**STAFF REPORT**  
**COMMUNITY DEVELOPMENT DEPARTMENT**

HEARING DATE: 4/23/2024  
TO: Mayor & City Council  
FROM: Stacy Hersh, Associate Planner  
208-884-5533  
SUBJECT: Foxcroft No. 3 FP  
FP-2023-0032  
LOCATION: Phase 3 is located at 3720 W. Pine Avenue, in the SE 1/4 of the NE 1/4 of Section 10, Township 3N, Range 1W.

Final Plat consisting of 30 residential building lots and 12 common lots on approximately 8.072 acres of land in the R-8 zoning district, by Kent Brown Planning.

B. Final Plat

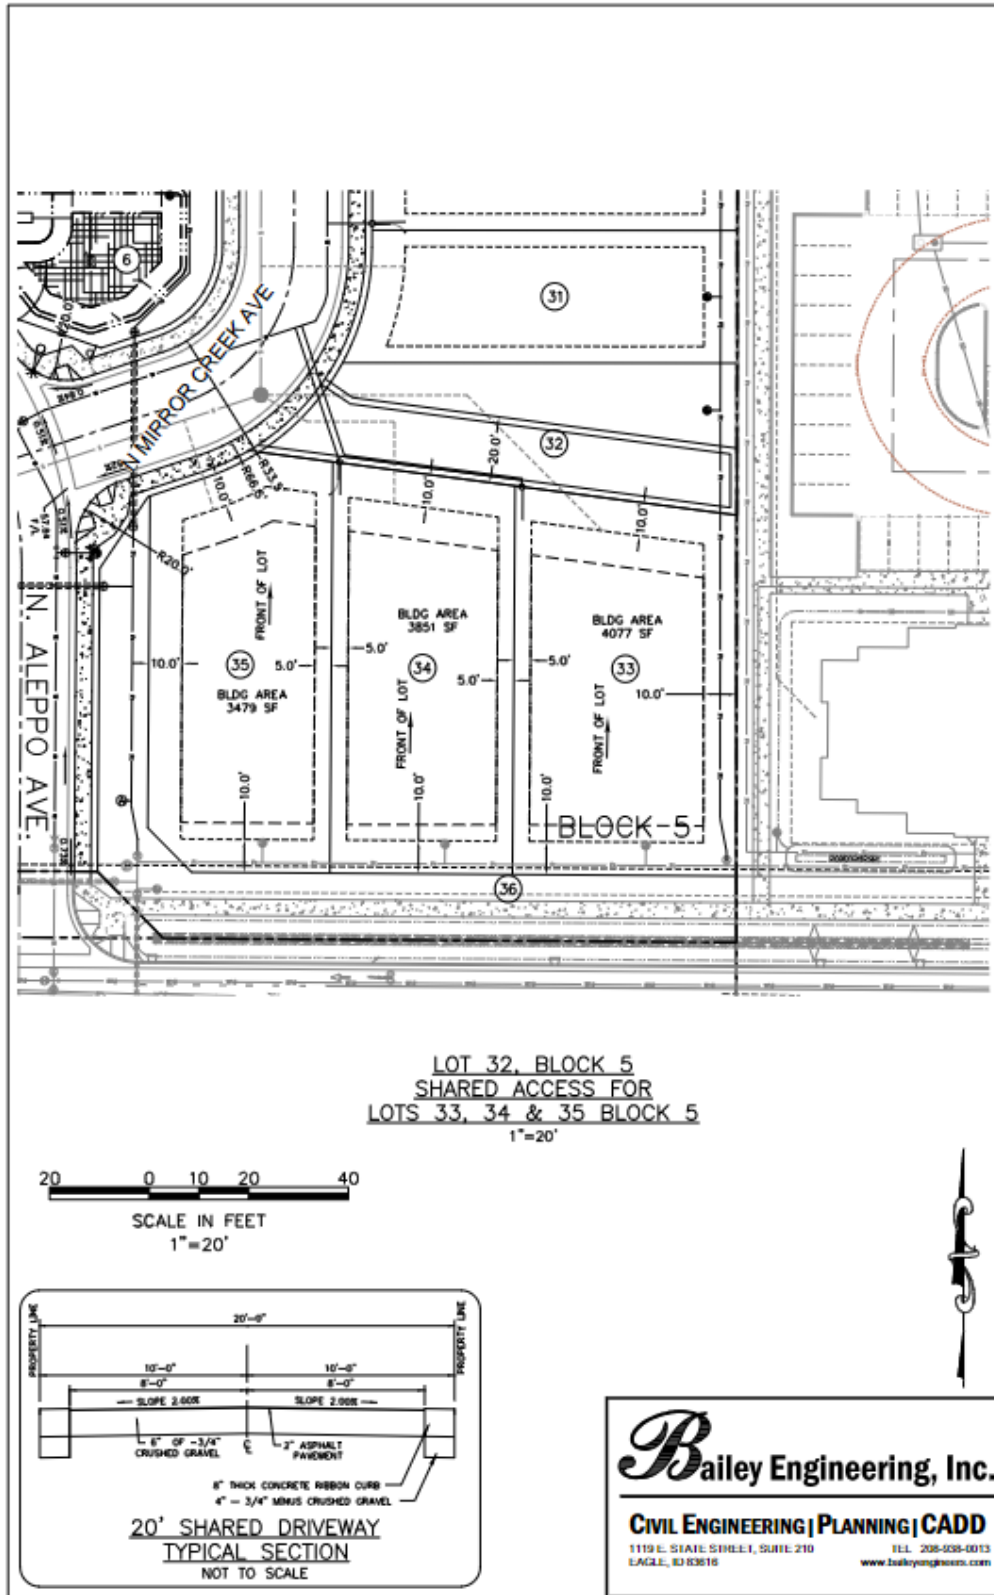
3. Prior to submittal for the City Engineer's signature, have the Certificate of Owners and the accompanying acknowledgement signed and notarized.
4. The final plat shown in Section V.B, prepared by Bailey Engineering, by Cody M. McCammon, is approved with the following conditions to be completed at the time of Final Plat Signature:

- a. Plat Note #11, add a reference regarding the maintenance of the common drives.
  - b. Plat Note #12, include recorded instrument number.
  - c. Plat Notes #14, include recorded instrument number.

- d. Add Note #15, include the recorded instrument number of the existing City of Meridian Development Agreement.
  - e. Add Note #16, include the recorded pathway easement number (ESMT-2024-0043) on the plat.
